Facility Impact and Funding Committee (FIFC) Report

11-January-2007

To evaluate validity and feasibility of the experiments planned in the Hadron Experimental Hall of J-PARC, the Facility Impact and Funding Committee (FIFC) of the Institute of Particle and Nuclear Physics (IPNS) was set up in the fall 2006.

Fig. 2.1 Layout of K1.8 beam line

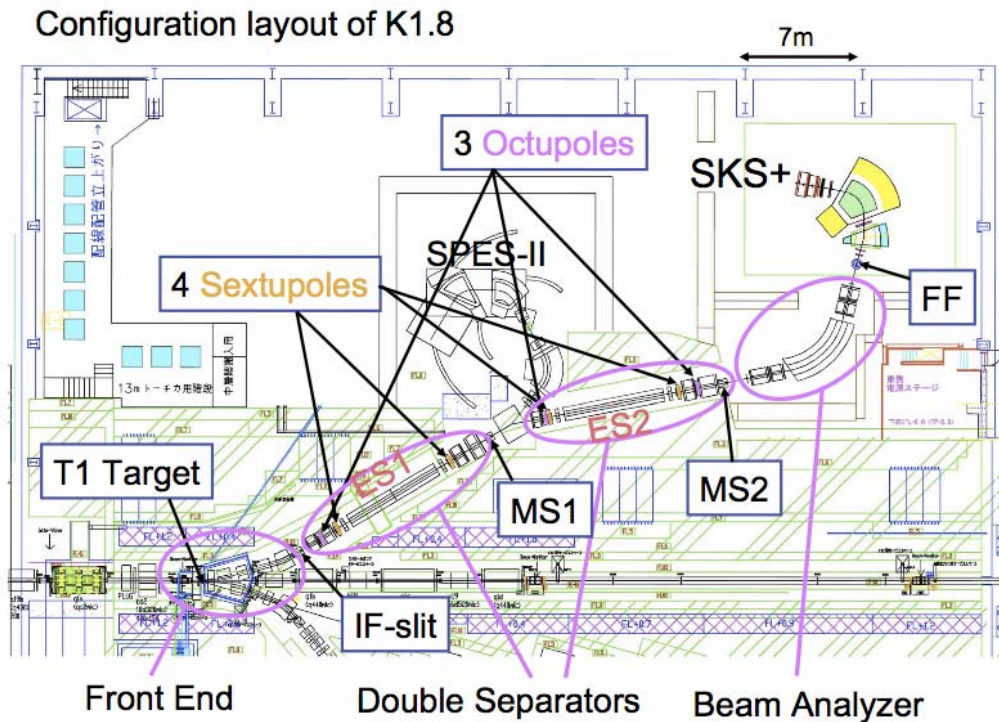
The committee agrees with the presented performance as a whole, although it wants to reserve some uncertainty in the estimate of K/π ratio. The counting rates in the tracking chambers are expected to be very high, especially at MS2. For the case of full-intensity operation some improvements on the tracking chambers should be necessary. This will be discussed more in the section 10.1.

Fig. 2.2 Layout of K1.8BR.

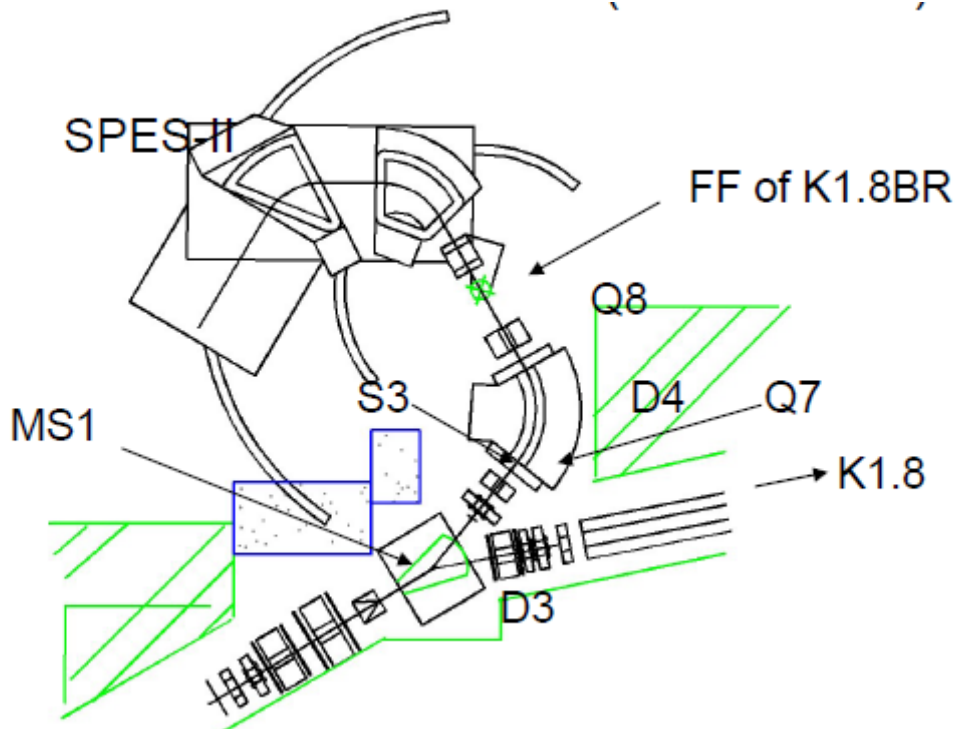
The committee accepts the proposed performance of this branch up to the K/π ratio which had better to be regarded with some ambiguity (more than K1.8). As was pointed out in the simulation calculation by Dr. Doornbos, the committee was concerned about the muon contamination in the beam, since it could influence on the experimental conditions and thus the detector design significantly. The committee recommends both the beamline designers and the users to evaluate it seriously soon.

Fig. 3.1 SKS Spectrometer.

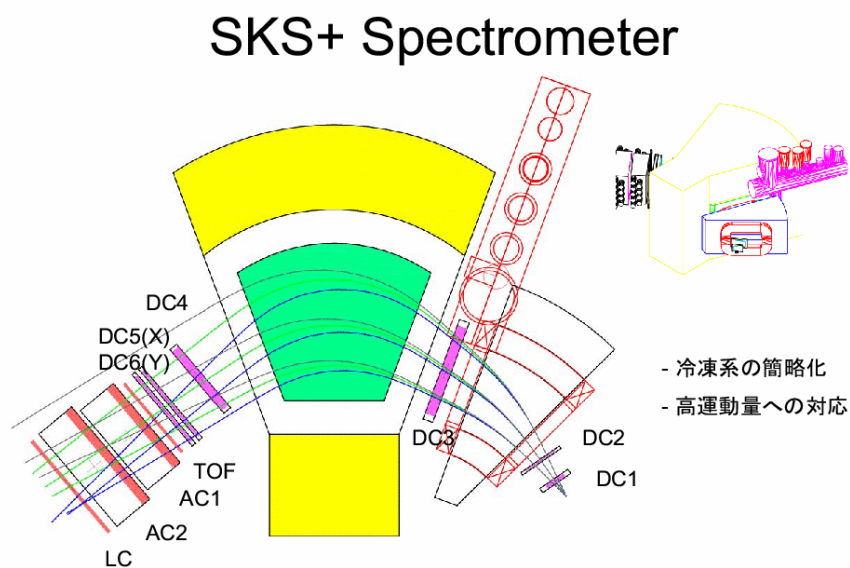
1) Good experience with the SKS magnet has been accumulated in the KEK-PS and no problems are foreseen in its reuse. The operation mode "SKS-minus" in which the magnet is operated at a reduced field also shows no problem.

2) The addition of the new "D" magnet for the E05 experiment is planned in the "SKS-plus" mode to focus the beam onto the chambers in the down stream whose resolution is $\sigma \sim 300 \mu\text{m}$. The committee discussed the possibility to realize a similar performance without the addition of "D" magnet by replacing DC3 and 4 with higher

resolution ($\sigma \sim 100 \mu\text{m}$) chambers as proposed in E13. This was checked to be possible by the E05 group themselves using an improved simulation. However, the size of the chambers must be wider because the beam would be focused weakly, and it seems difficult to keep the original resolution of $\sigma \sim 100 \mu\text{m}$ for a long time over such a wide area. Therefore, the committee endorses the original plan with the addition of the "D" magnet.

Fig. 6.2 Sensitivity dependence on statistics. The x -axis shows ratio to statistics at the Phase I full intensity beam condition

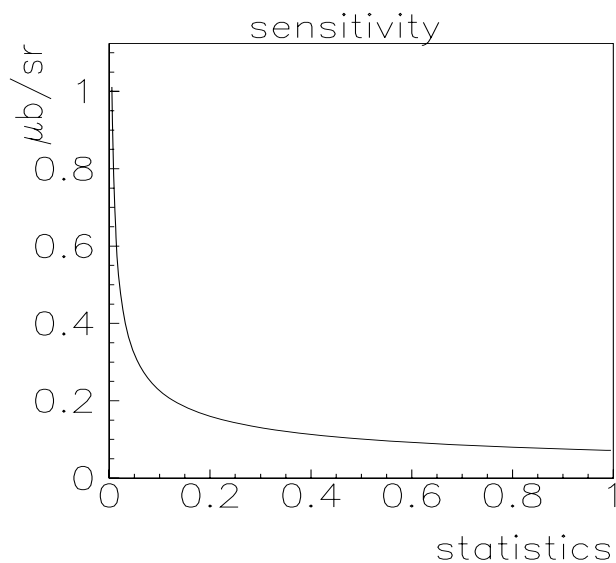
2) Optimization of statistics and feasibility should be considered in a reasonable manner. As shown in the figure above, a significant sensitivity would be achievable with rather low statistics (namely low beam intensity). The reasonable goal of the experiment should be discussed in PAC.

Fig. 7.1 Layout of E07 experiment.

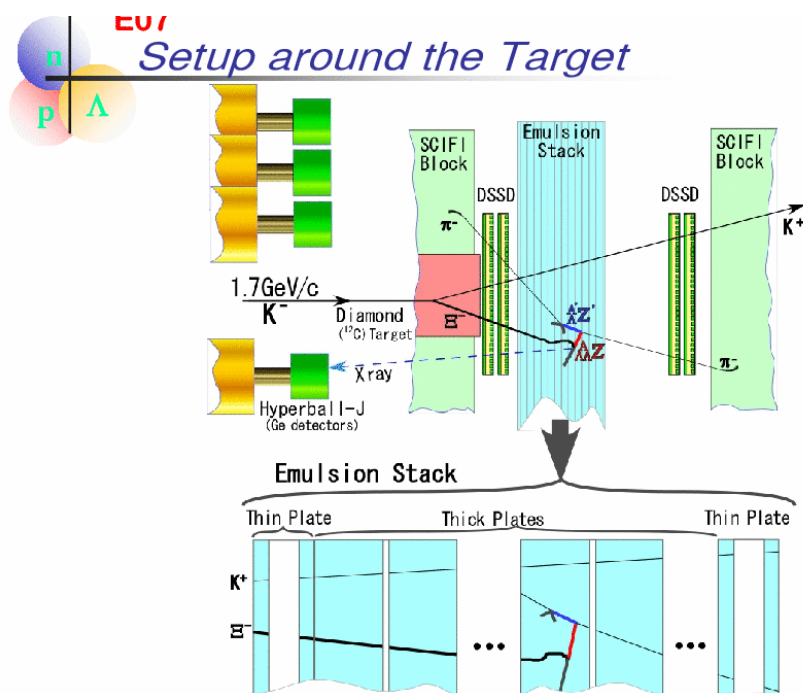
The committee does not foresee any technical problems in this setup and basically endorses the original design of the experiment. However, there are two concerns raised. One is related to the choice of a spectrometer magnet. The use of the SKS magnet instead of the originally proposed KURAMA would reduce the acceptance by a factor 2. This reduction will reflect directly to the total amount of the emulsion. Apparently there is no strong reason to use SKS unless a technical difficulty to remove SKS or to let KURAMA coexist with SKS is encountered. Therefore the committee favors the use of KURAMA for this experiment.

Another concern is on the method to align two DSSDs and the emulsion stack. It is normally achieved using a high statistics beam data. However, it might be difficult to use tracks recorded in the emulsion for this purpose since the stack is frequently replaced and number of tracks used for the alignment is limited. Since the question has not yet answered to by the experiment, the committee expects to hear the strategy on this issue from the group at the coming PAC.

Figure: The Detector of E17

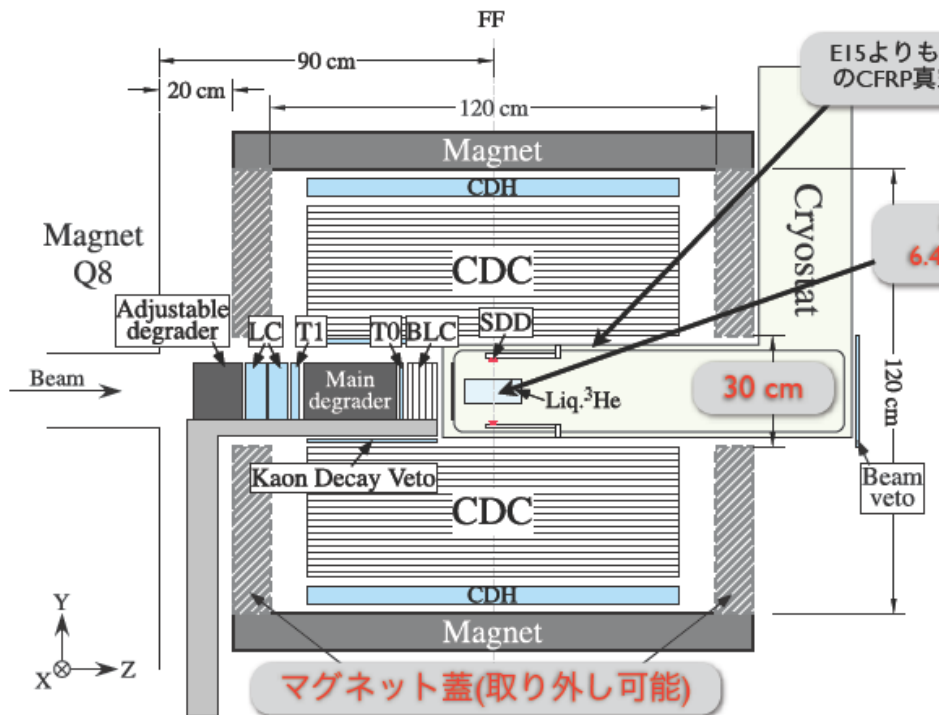
The committee understood that SDD is the best X ray detector for better energy resolution with a larger acceptance. The committee would like to ask the group for the tolerable hit rate of the charged particles at SDD and the estimation at E17. Especially, the committee is interested in the acceptance of the foils which extend to SDD. Also, the beam profile with halo should be shown in the target region. The existence of muon contamination with halo which amounts 1.75 times of the total kaon flux was pointed out in the course of the K1.8-BR beamline review. The committee recommends that its influence should be worked out.

Since the gain can be calibrated real-time by in-situ energy calibration, the drift may not have a relevant error. However, the committee would like to encourage the group for detailed investigation of the systematic errors originated from gain variations. E570 has already shown the performance of discriminating 40eV energy shift. To examine the shift of less than 10 eV from the recent theoretical calculation, E17 must have the systematic error similar to the statistical one as small as 2 eV. The committee may suggest both measurements with ^4He and ^3He for enhancing signals to see consistent results. Therefore, the committee would like to ask the group to report the detailed evaluation of the systematic errors of E17 and the error estimated at E570 to PAC.

Figure 10.1 K1.8 beam-line. Two gas chambers (BC1 and BC2) are installed near MS2 (mass slit) and, three (BC3, BC4 and DC1) are installed near FF in K1.8 for tracking of incident particle.

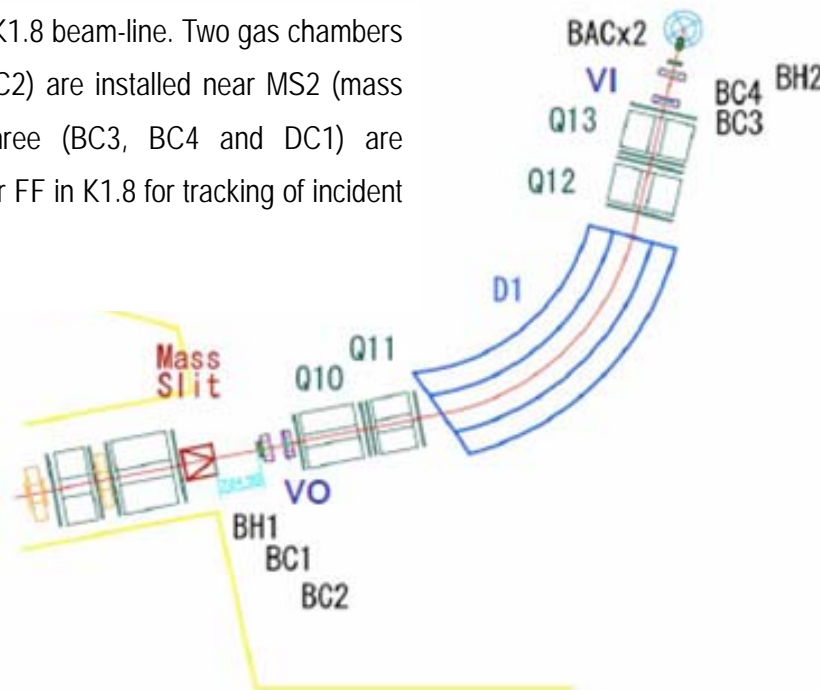
Fig. 10.1 shows the downstream part of the K1.8 beam-line. Five gas detectors (BC1, BC2, BC3, BC4 and DC1) will be operated under a high intensity beam condition. BC1 and BC2 are installed around MS2, and BC3, BC4 and DC1 are installed around FF. The tracking efficiency with those detectors should be kept as high as possible even under the high count rate beam condition. Here we concentrate on the discussion of
